Addendum Number 1

Issued 4/26/2024

Franklin Active Adult Center (AAC)

160 E. Adams St.
Franklin, IN 46131

2 SECTION THROUGH PLATFORM LIFT
1/2" = 1'-0"

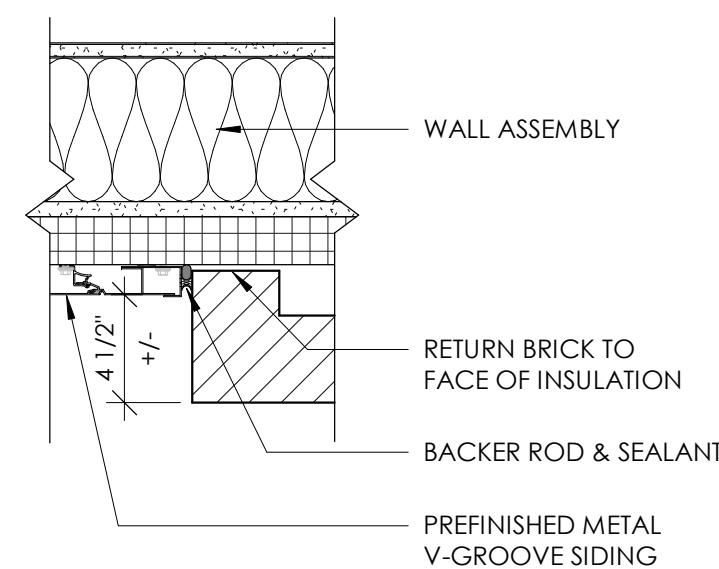
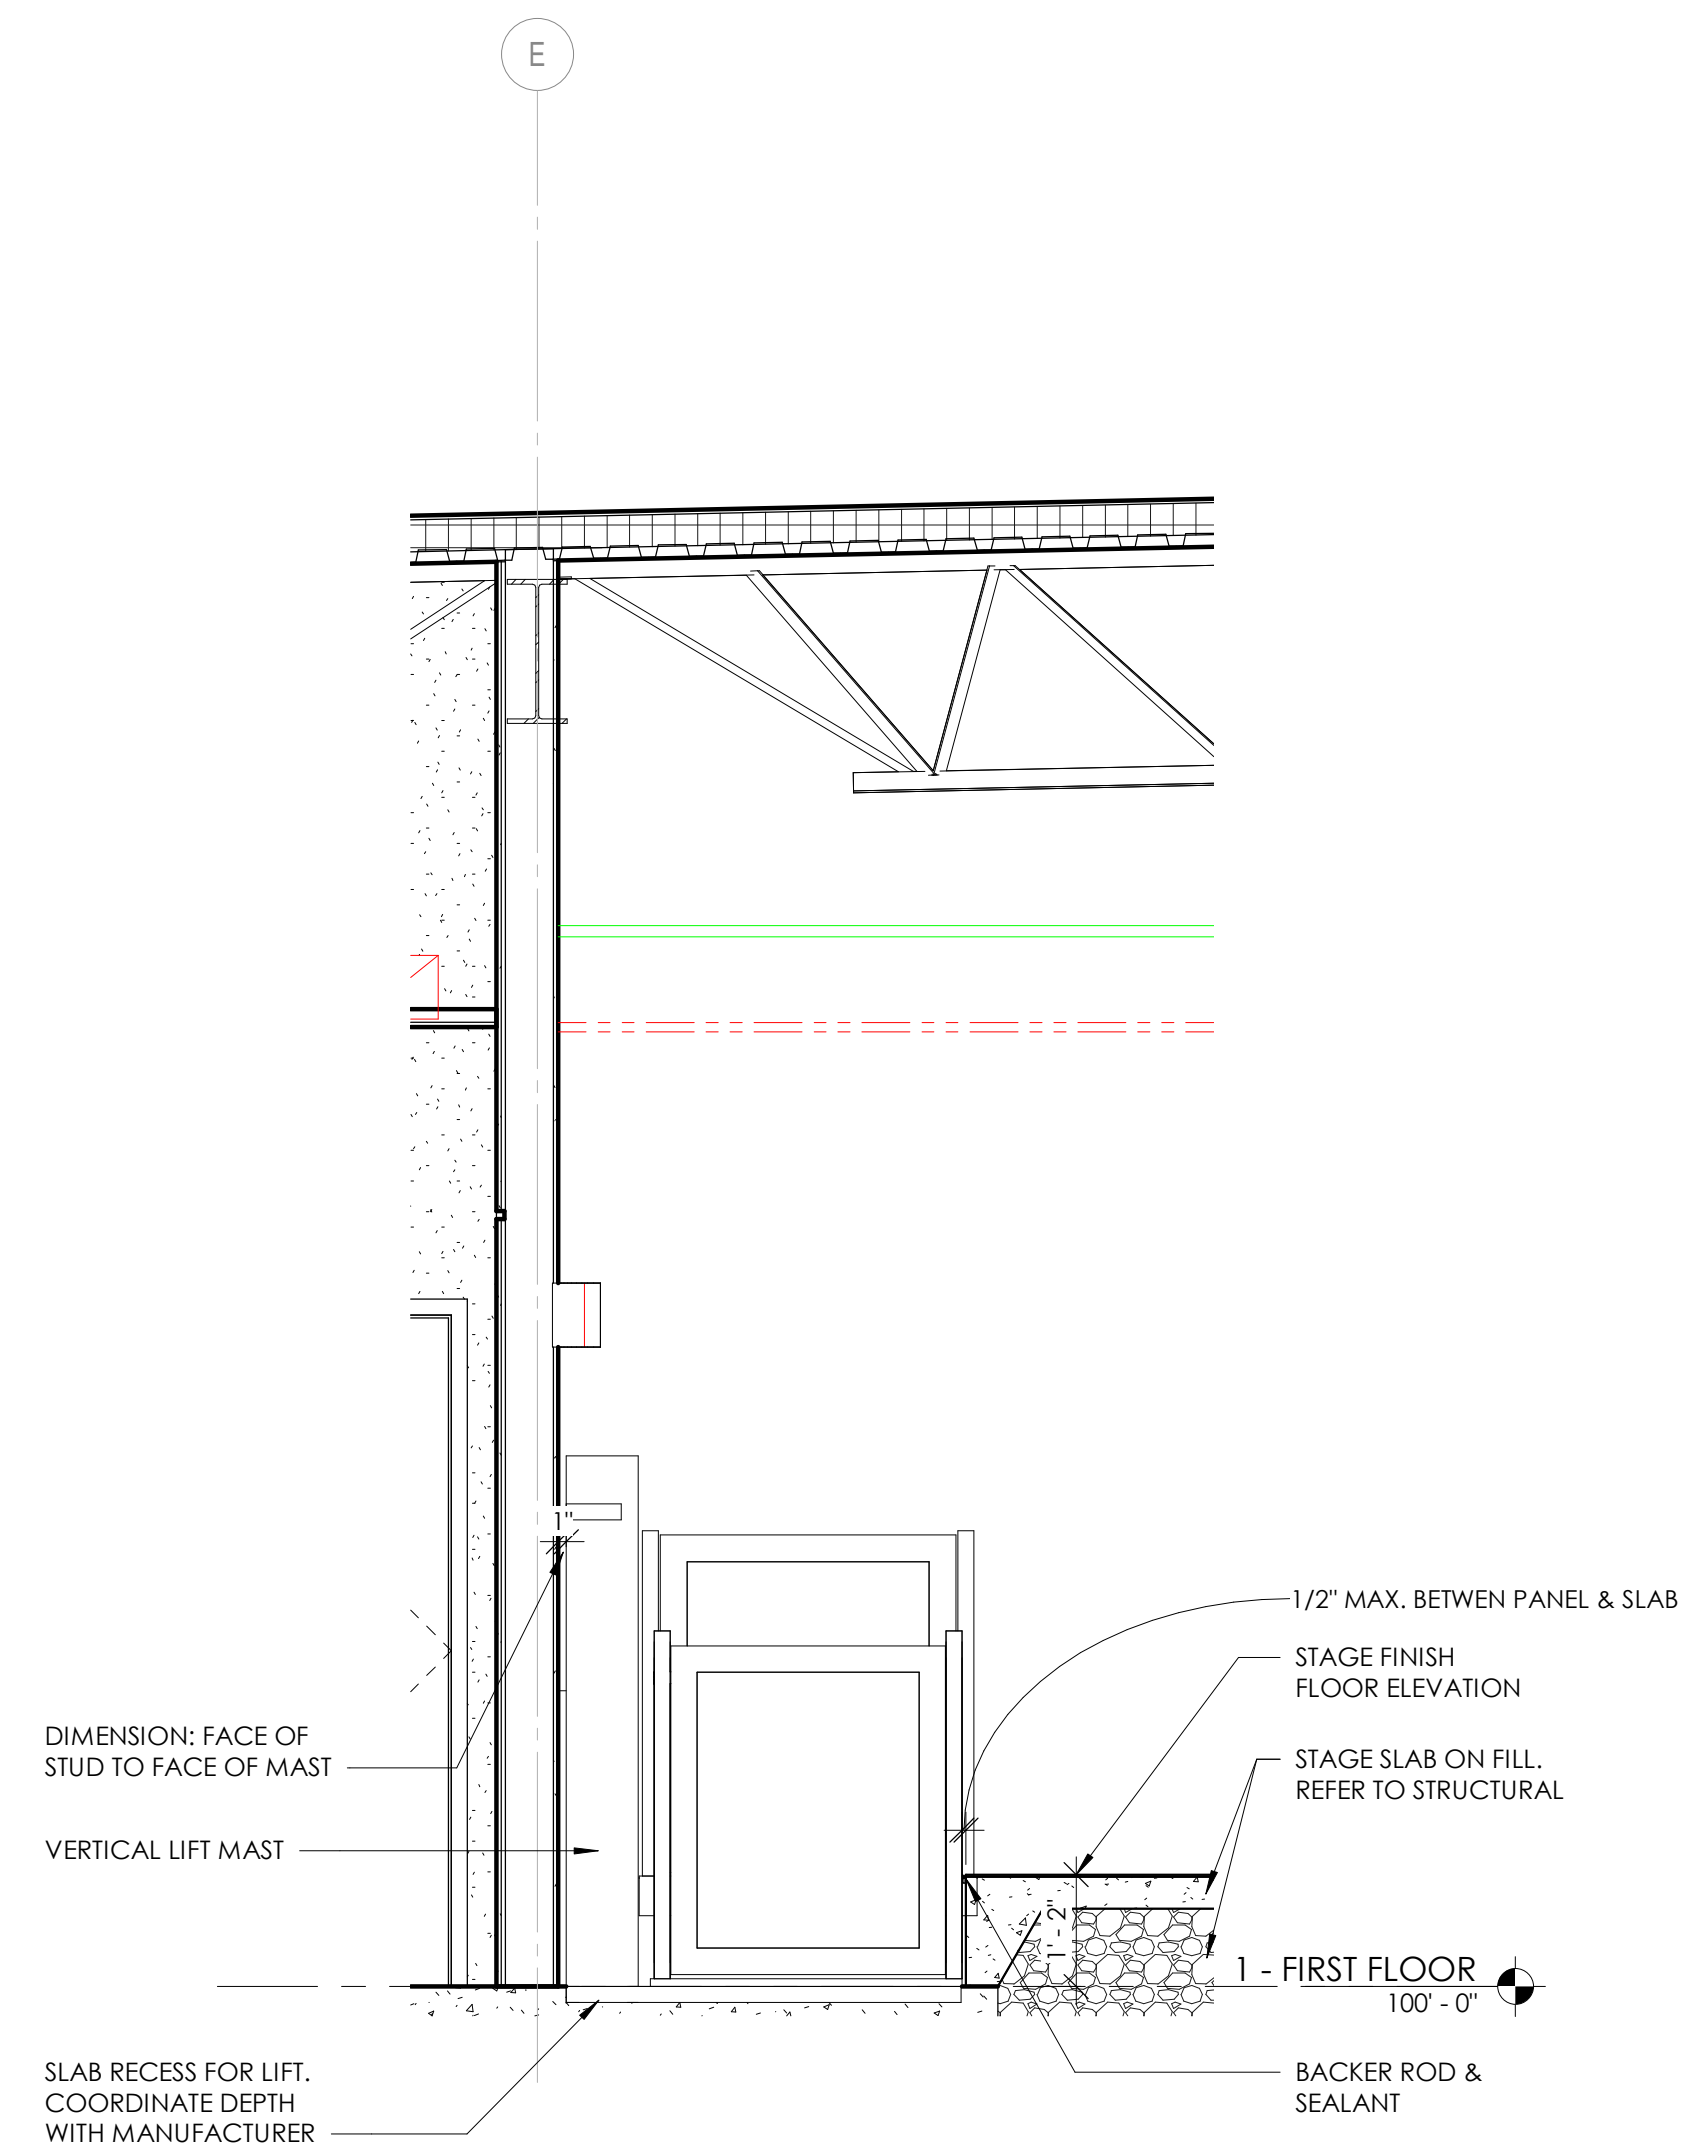
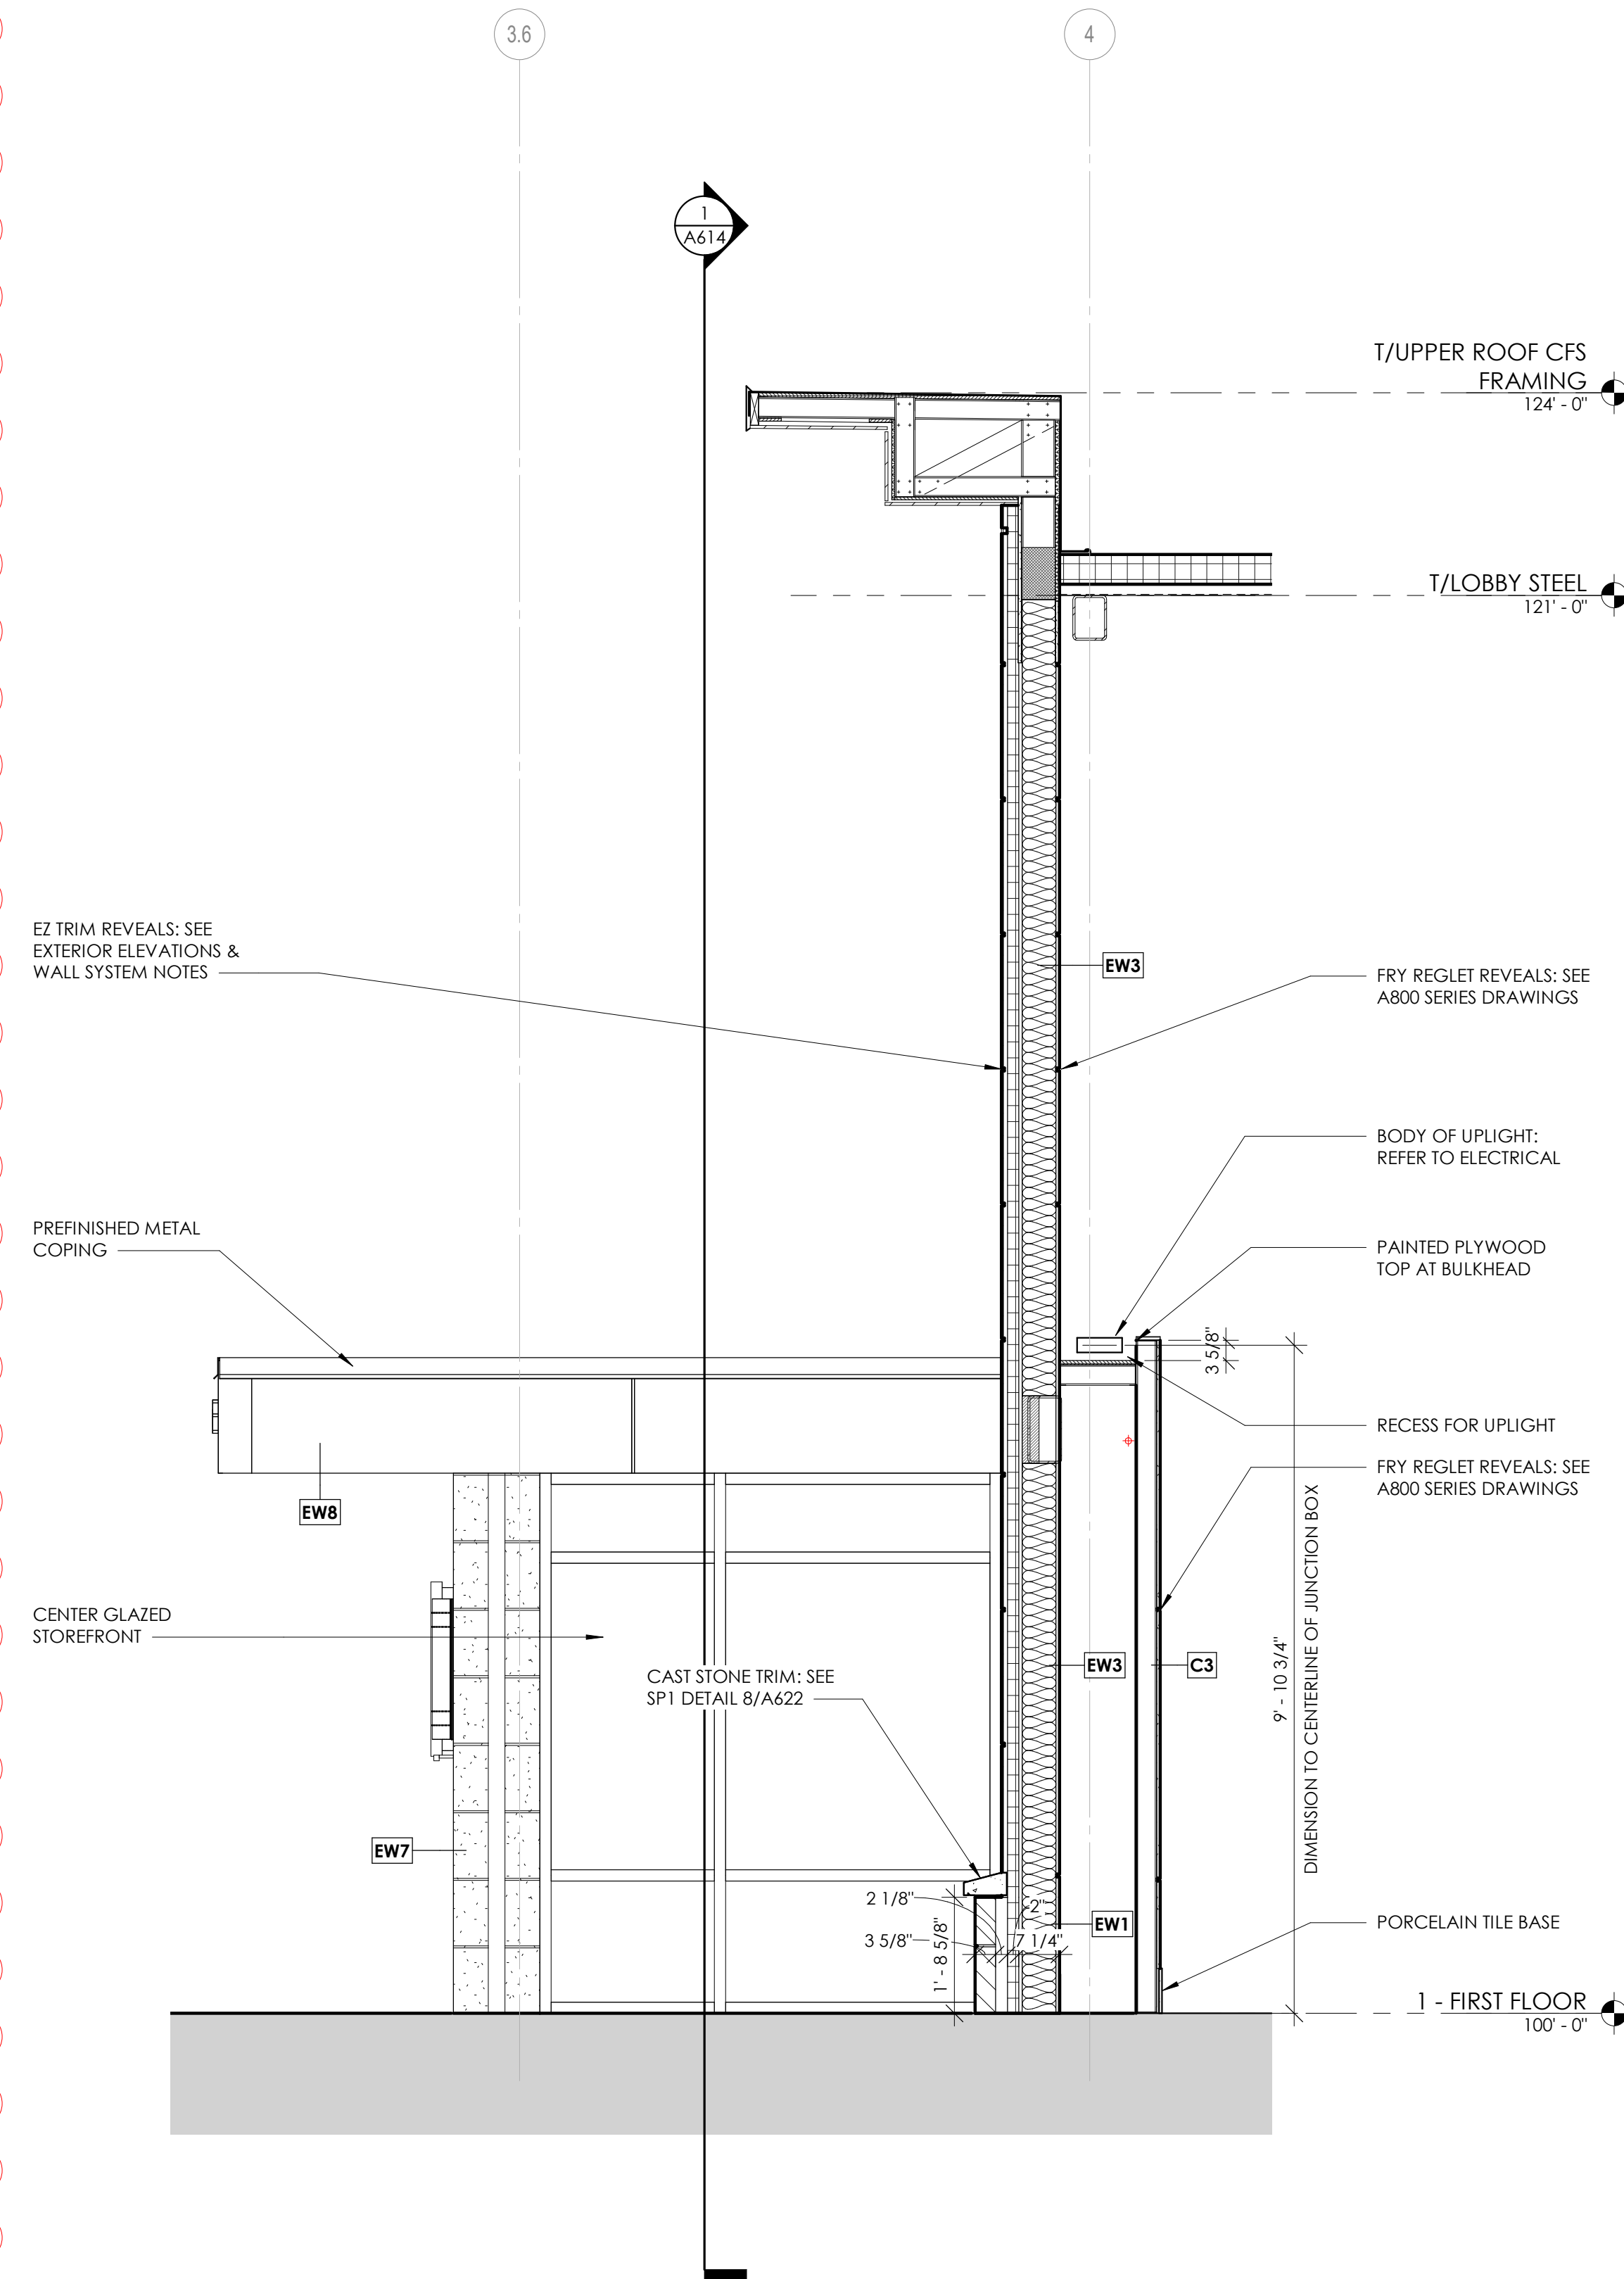
- Item No. 31** Sheet A615: Add Wall Section 2 through platform lift. Add Details 3 and 4 illustrating transition from brick to metal v-groove siding and brick to fiber cement siding. Attached.
